RE: Mister Car Wash – Parker Pointe Subdivision – Parker, CO

This drainage conformance letter is for the proposed Mister Car Wash (MCW) pad development on Lot 13 of the Parker Pointe overall development in Parker, Colorado. The objective is to show that the proposed drainage design for the site conforms with the “*Final Drainage Report – Parker Pointe*” (Overall Report) prepared by Perception Design. Excerpts from the Overall Report are included in

Custom Soil Resource Report
Soil Map

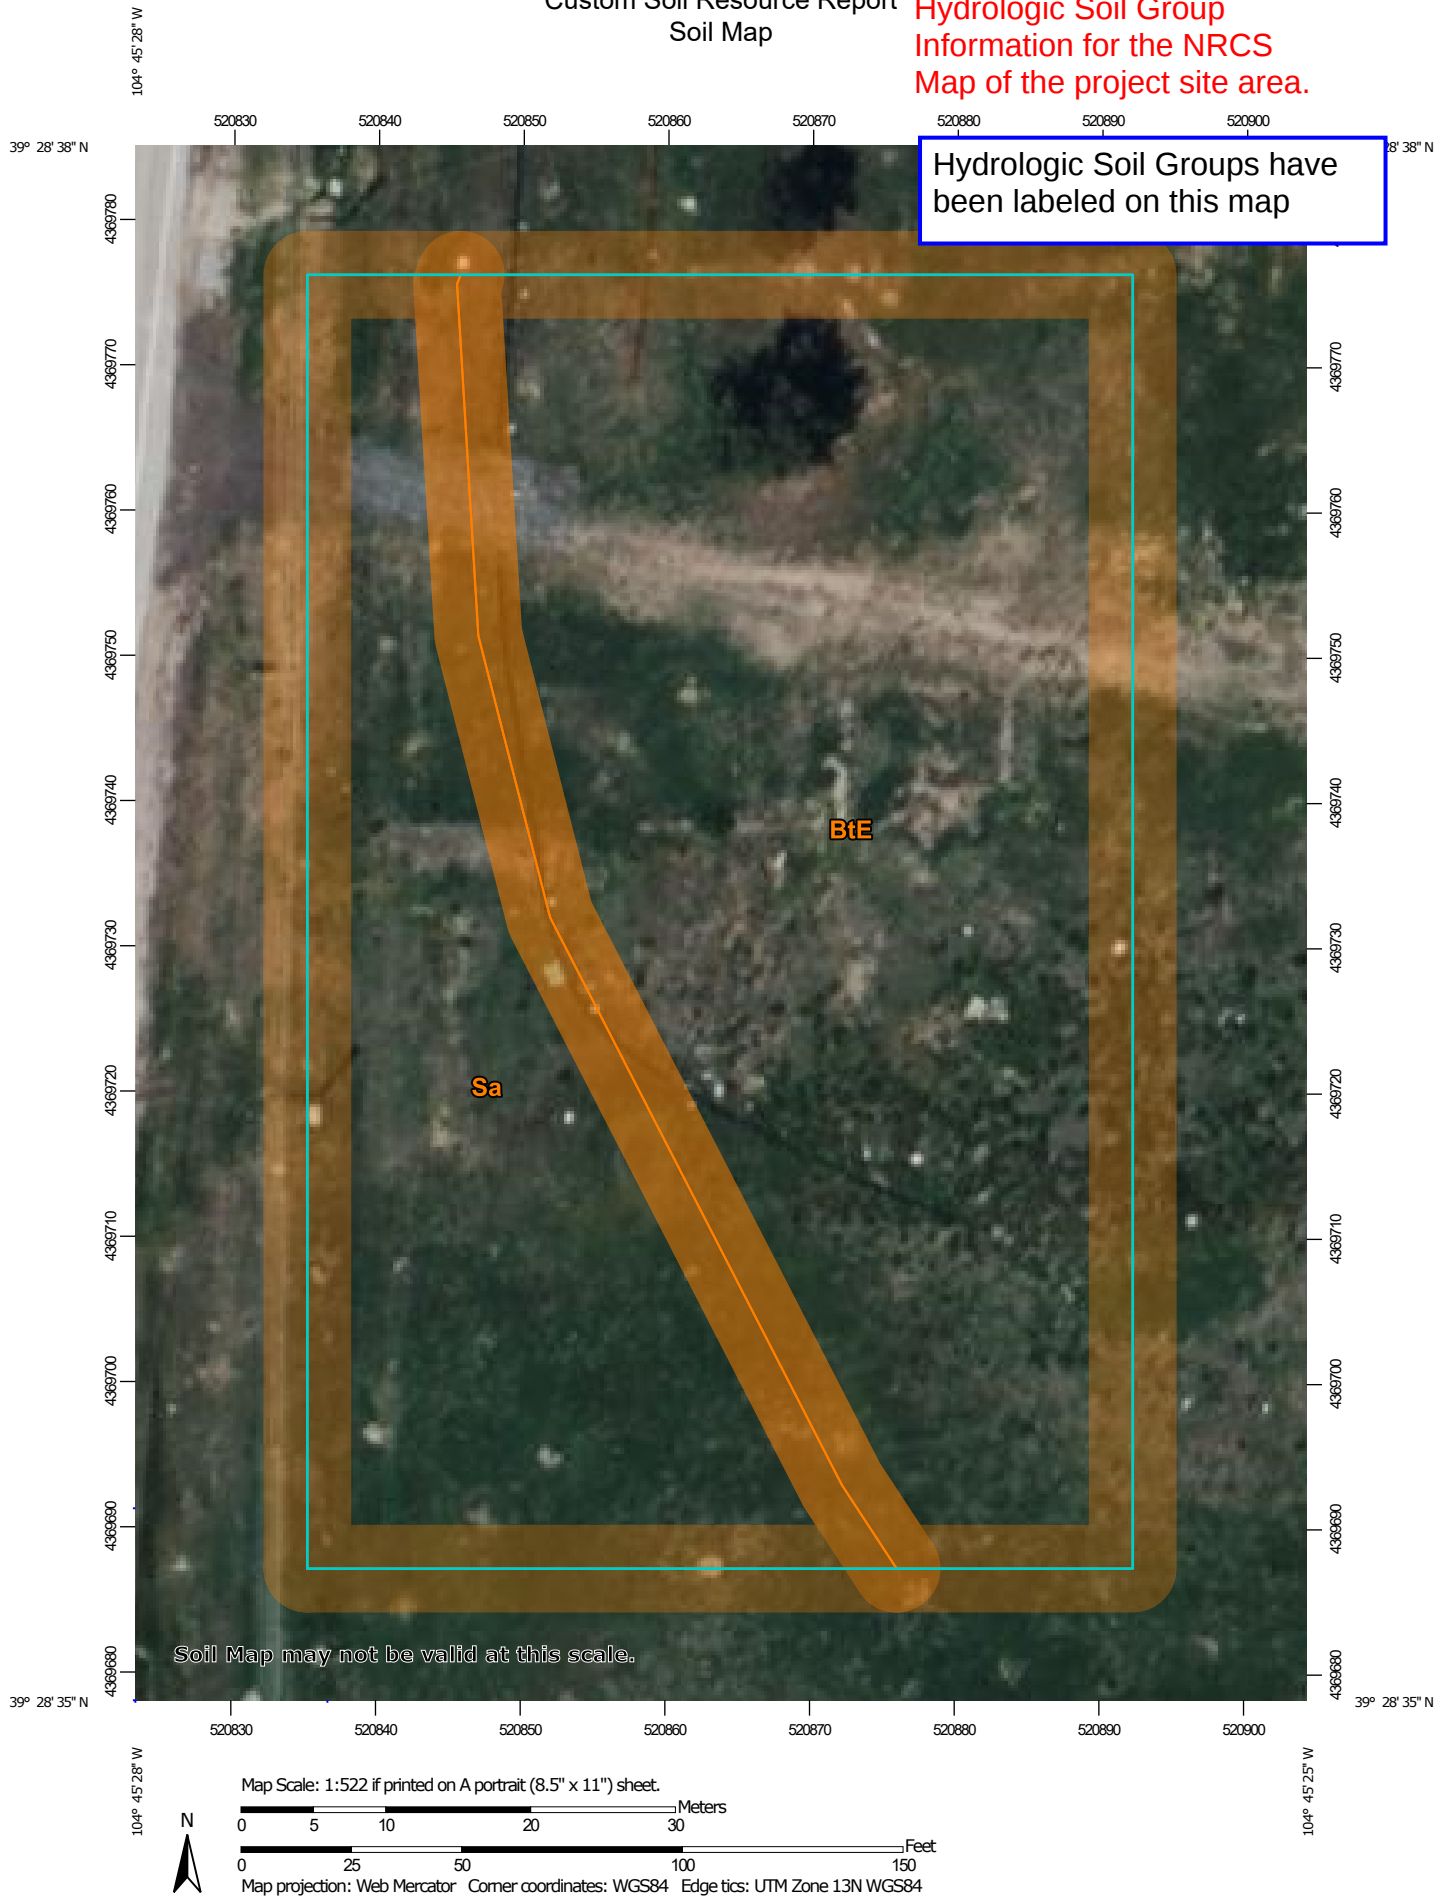
Please include the
Hydrologic Soil Group
Information for the NRCS
Map of the project site area.

Hydrologic Soil Groups have
been labeled on this map
